<b>Submissions</b>
--------------------

**Combined Objection to a Development Application: D/2023/727  
No.10, Onslow Avenue and No.21C, Billyard Avenue,  
Elizabeth Bay - Residential Flat Building  
Visual Impact Assessment Report, September, 2023**

Project:  
SHADOW ANALYSIS REVIEW  
NO 10 ONSLOW AVE & 21C BILLYARD AVE  
ELIZABETH BAY NSW  
CLIENT: DARNLEY HALL PTY LTD

Figure 3 – East elevation, indicating height exceedance in red overlay. Smart Design Studio.

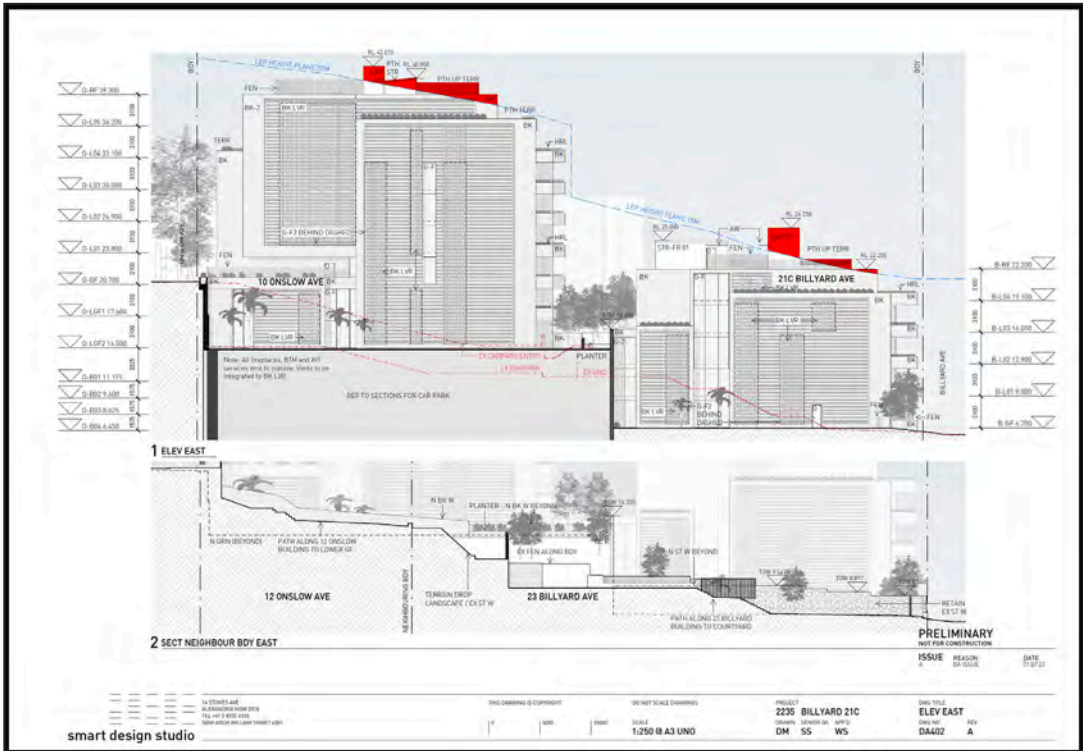
The subject site is classed as Zone R and also Zone O. The subject site is therefore considered to have two maximum permissible heights of 15 metres to the north-east and 22 metres to the south-west. The proposed development is confined to the 22 metre height limit portion of the site. The proposal exceeds both of these building height controls, which will require a Clause 4.6 Variation Request to justify this exceedance, particularly in relation to view loss and visual impact to neighbouring properties.

**Figure 1: Maximum Building Height Under *Bettar***

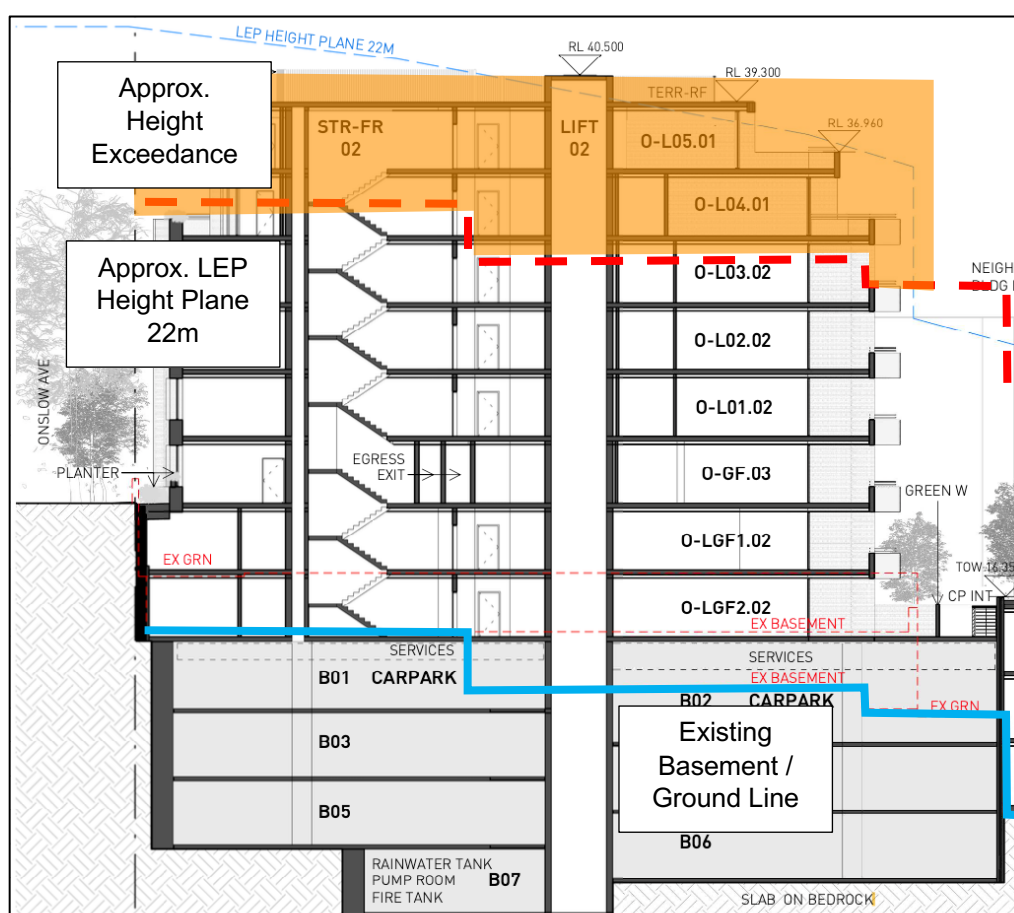
Accordingly, the underside of the slab of the existing basement at 10 Onslow Avenue should be taken at the existing ground level, reflecting the ordinary and natural use of the word 'existing'. The LEP Height Plane line should then be reflected directly above the configuration of the existing basement line direct below (see **Figure 1**). Had the applicant used this method for height calculation it is likely that the height breach would be much more significant than currently shown. Whilst we are unable to provide our own exact calculation, it would appear to result in a breach of at least one storey.

The Clause 4.6 written request has assessed the wrong extent of the breach and therefore has not conclusively demonstrated the various tests in the clause. Given the extent of the breach is likely much more significant than currently assessed against,

**Figure 5: Proposed Side Setback (Habitable Rooms)**

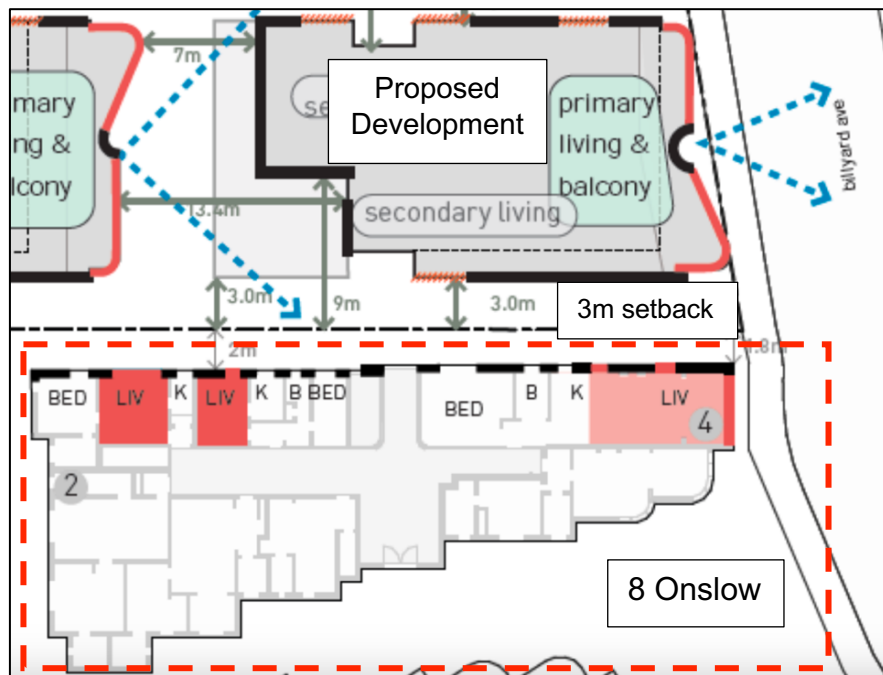
With the proposal having a purported maximum building height of 24.13m and maximum of eight storeys (Onslow Avenue side) the proposed minimum side setback of 3m to 8 Onslow Avenue is in breach of the ADG requirements and will result in additional privacy, acoustic and solar loss impacts. It is noted that Council raised this non-compliance with the applicant at a Pre-DA meeting. Instead of addressing Council's concerns, the applicant has seemingly arbitrarily used the 3m non-habitable setback criteria as a 'base to work from'. Whilst it is unclear why the incorrect setback has been selected, it is also misleading as the building faces several habitable rooms in 8 Onslow, as shown in **Figure 5**. The rooms include bedrooms, living rooms and dining rooms which have been incorrectly identified on the submitted drawings.

It also appears the applicant has misinterpreted the definition of a 'habitable' room in Figure 11 in the SEE. The Building Code of Australia (BCA) defines a habitable room as meaning:

**Proposed**  
**Figure 6: Prevailing Front Setback (Onslow Avenue)**

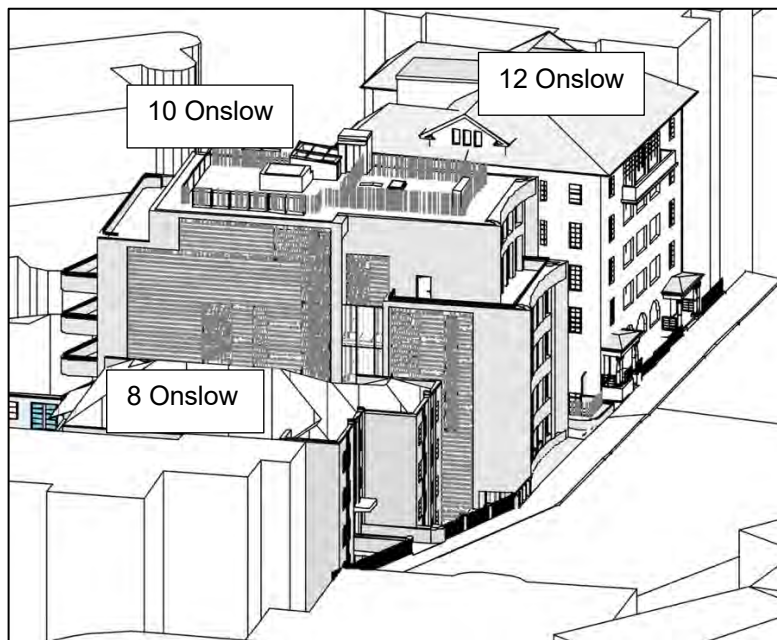
The proposed front and rear setbacks of the Onslow Avenue building are inconsistent with the neighbouring developments and therefore does not comply with the Sydney Development Control Plan (DCP) 2012 controls. The proposal exceeds the prevailing front and rear setbacks of the neighboring buildings along Onslow Avenue and will result in unacceptable impacts.

Section 4.2.2.1, Clause 1 of the DCP requires buildings to be consistent with adjoining buildings where there are no setbacks shown in the Building Setback and Alignment map. The proposed front setback for the design is a zero-setback from Onslow Avenue, with the justification only taking into account only one neighbouring building. The design has failed to take into account the prevailing front setback in relation to our building, which shows a tapered front setback (see **Figure 6**).
